**CITY OF SHERWOOD  
PLANNING COMMISSION STAFF REPORT  
MARCH 1, 2022**

**OLD TOWN APARTMENTS  
SITE PLAN REVIEW, CLASS A VARIANCE  
LANDMARK ALTERATION, MINOR LAND PARTITION  
LU 2021-025 SP / VA / LA / MLP**

Figure 1: Lot 1 at 40,157 SF with requested variance

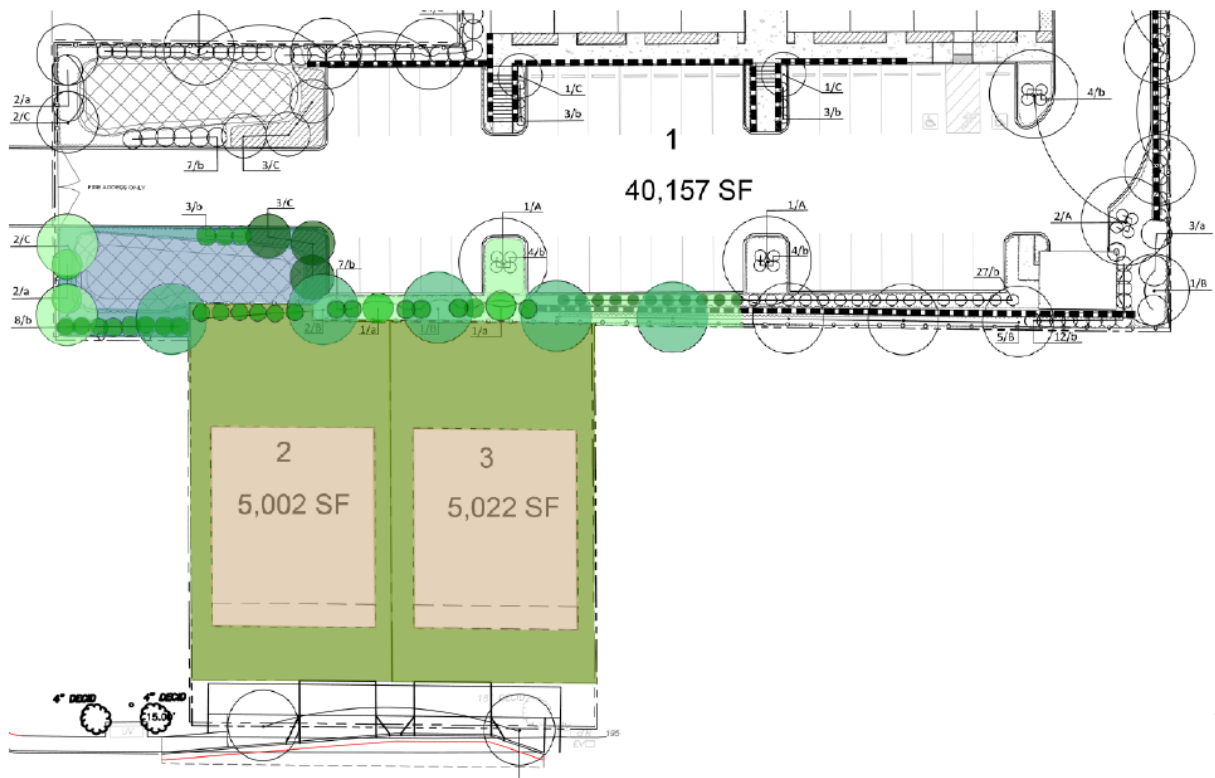
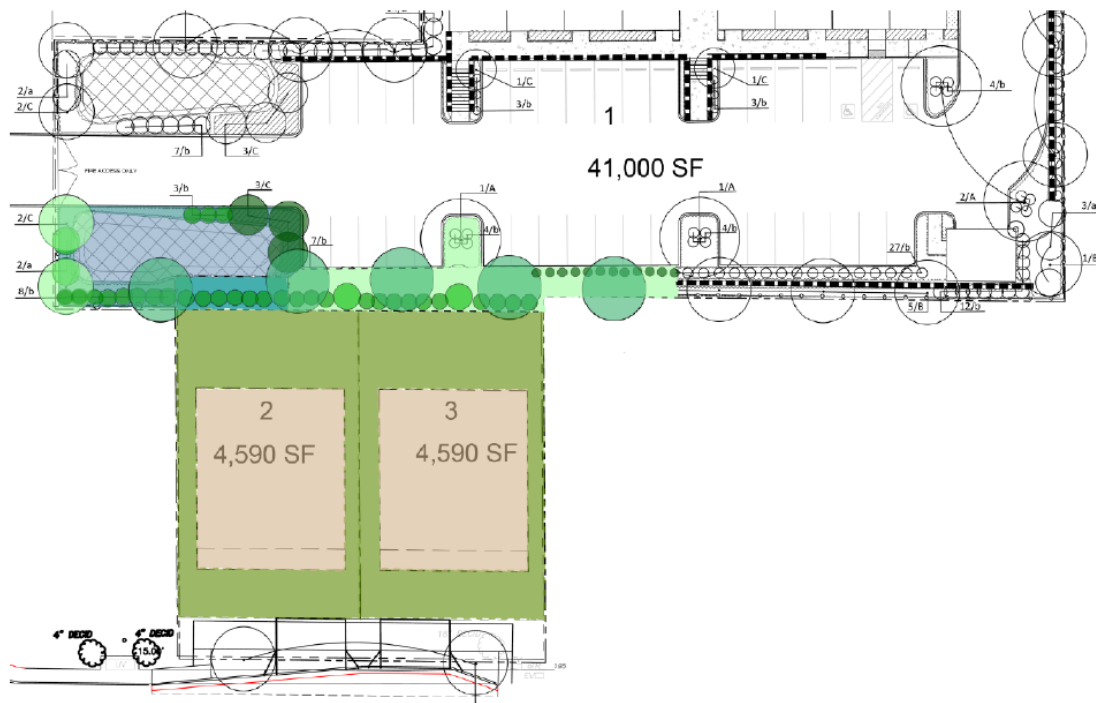
The location of the area in question also limits the potential for adverse impacts. With its irregular shape; 3 street frontages; and significantly varying width and depth across its length, it is impracticable to create a single cohesive development on the site. All frontages have limited access, with permanent access to Parcel 1 ultimately required to be taken to SW Columbia Street from the north east corner of the site. As part of the neighborhood meeting for the development, a comment was received was from a neighbor on SW Willamette Street who was concerned in part about compatibility and the streetscape on SW Willamette Street. At that time the applicant looked at the existing single family detached nature of Willamette, especially the Medium Density Residential Low development on the south side, and determined that single-family detached would provide a more consistent and appealing streetscape. In order to provide 5,000 square foot single-family detached parcels on SW Willamette Street in addition to the 12-foot-wide right-of-way dedication requested by the City, the applicant has moved the rear property line of the single-family parcels northwards, resulting in Parcels 2 and 3 with lot areas of 5,002 and 5,022 square feet respectively. Effectively,

as shown below, the 843 square feet has been eliminated, the property line has simply shifted north and the additional perimeter parking area landscaping, is transferred to the single-family lots as a usable rear yard area.

While the loss of the 843 square feet from Parcel 1 will be unlikely to be noticed by residents of the site, surrounding residents, or the general public, the ability to provide a consistent streetscape on SW Willamette Street and additional outdoor yard area to Parcels 2 and 3 will have significant, realized benefits.

**ANALYSIS:** Staff concurs with the applicant response. As shown in Figures 1 and 2 above, the loss of 843 SF on Lot 1 will allow a more compatible development type (single-family homes) along SW Willamette St. while having a minimal impact to the multi-family lot.

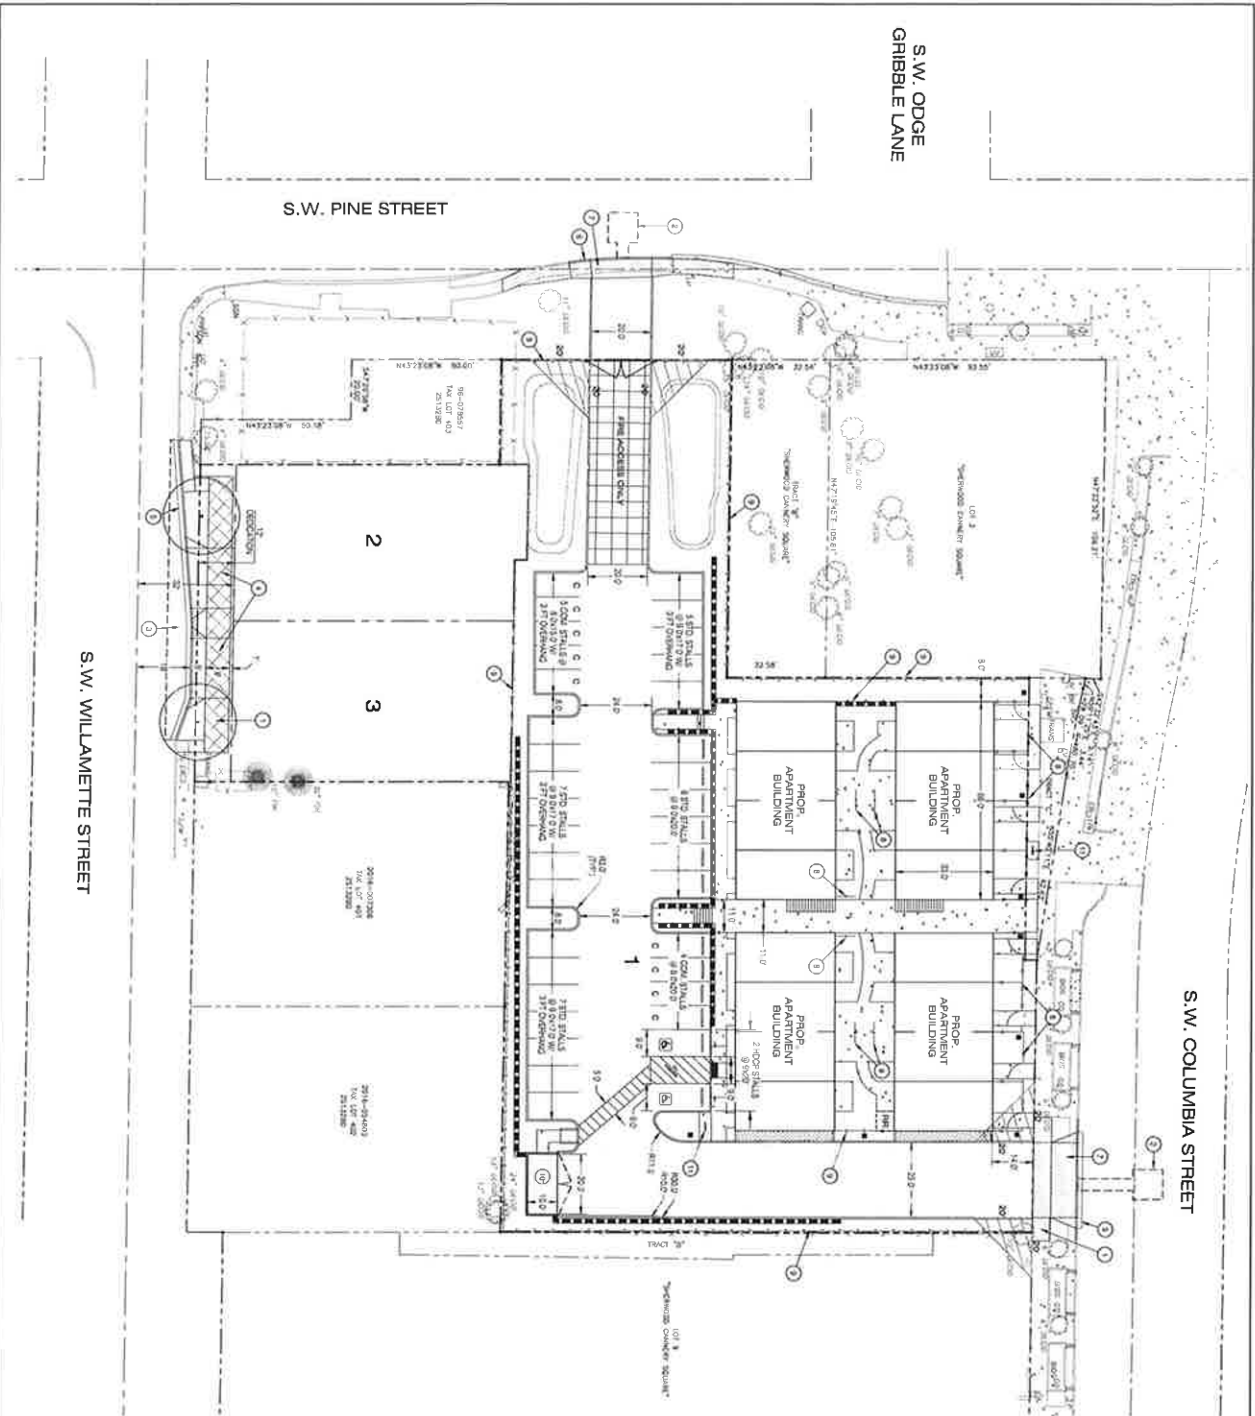
We have reviewed the site plan for the above-mentioned project. The site plan shows one enclosure on the property measuring 10' x 20' and allows for straight on access.

The other details on the site plan are not shown. These requirements will need to be met to ensure our access:

- The gates need to be hinged in front of the enclosure walls to allow for the full 10' width. This will also allow for the 120-degree opening angle that is required.
- No center post at the gate access point.
- The gates need cane bolts and holes put in place for the gates to be locked in the open and closed position. The holes for the gates to be held open need to be at the full 120 degree opening angle.

Any future modifications to the attached plan will need to be approved by us prior to any construction being done.
